RETREAT AT TIMBERRIDGE FILING NO. 3

CONSTRUCTION DRAWINGS

RETREAT AT TIMBERIDGE FILING NO. 3
CONSTRUCTION DRAWINGS
STREET SECTIONS / EROSION CONTROL NOTES

BREEZE GRAVEL REGIONAL MULTI-USE TRAIL SECTION
NOT TO SCALE

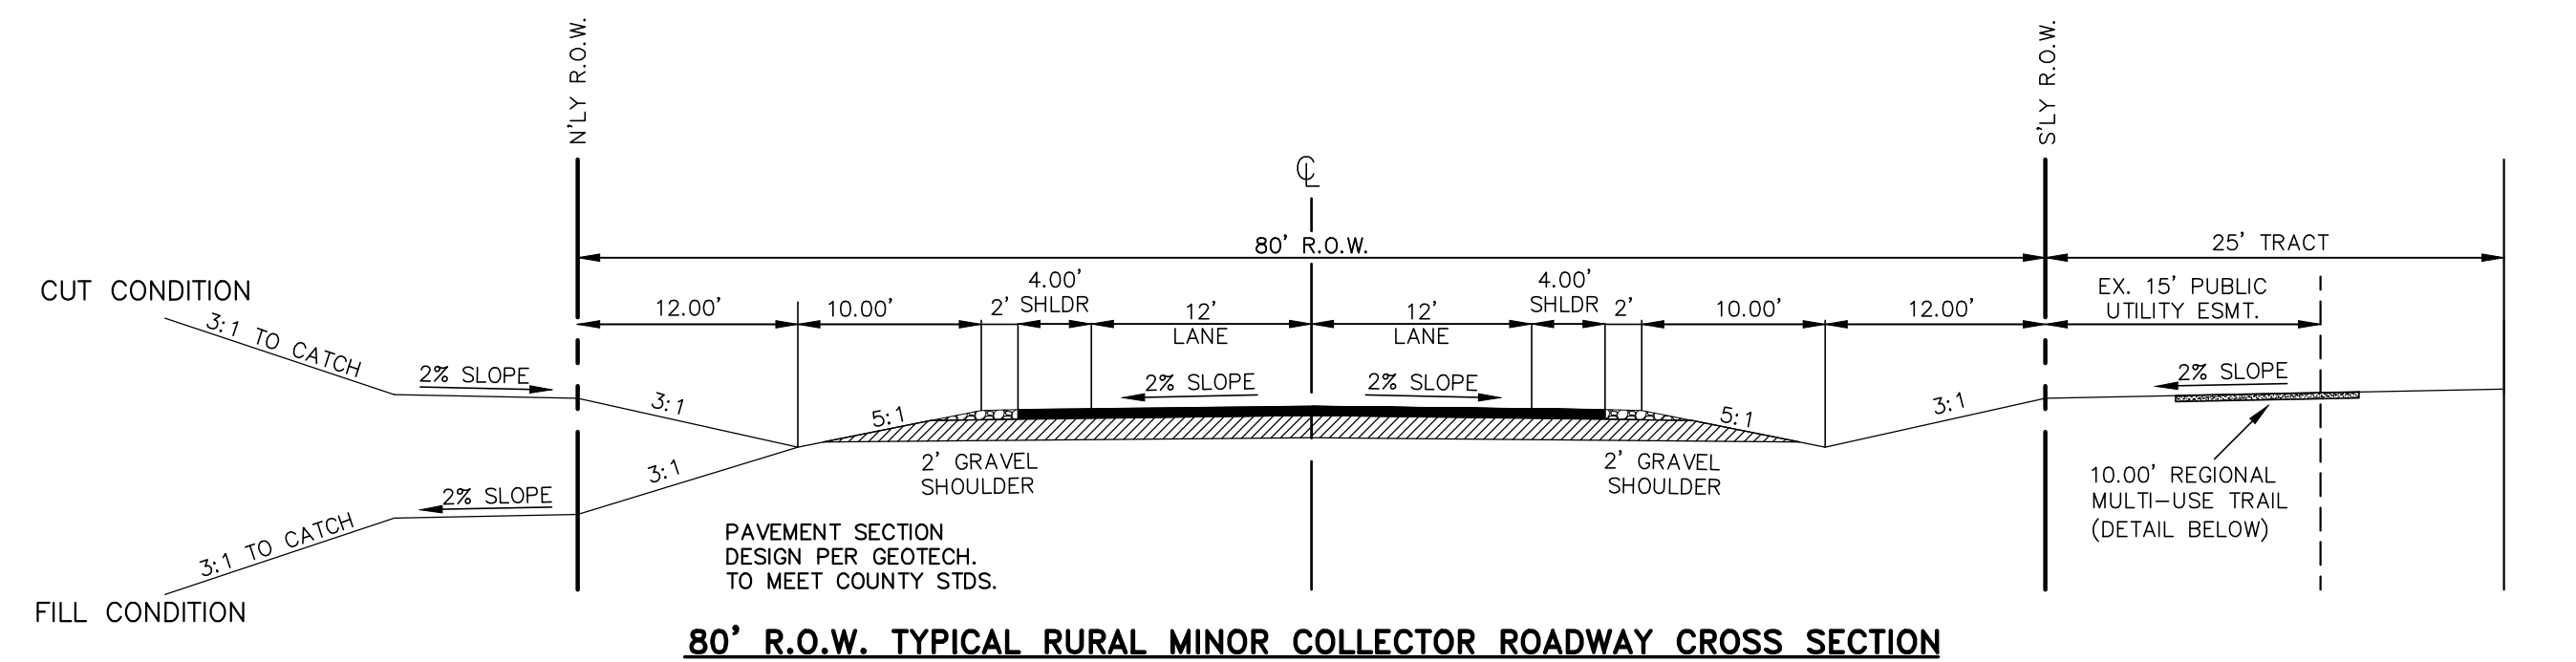
For Sand Creek Regional Trail and Arroyo Lane Regional Trail, the crusher fines need to be 6" thick OR 2" of road base with 4" of crusher fines. Regional trails may be 8' with 2' mowed shoulders per this detail (full detail will be uploaded).
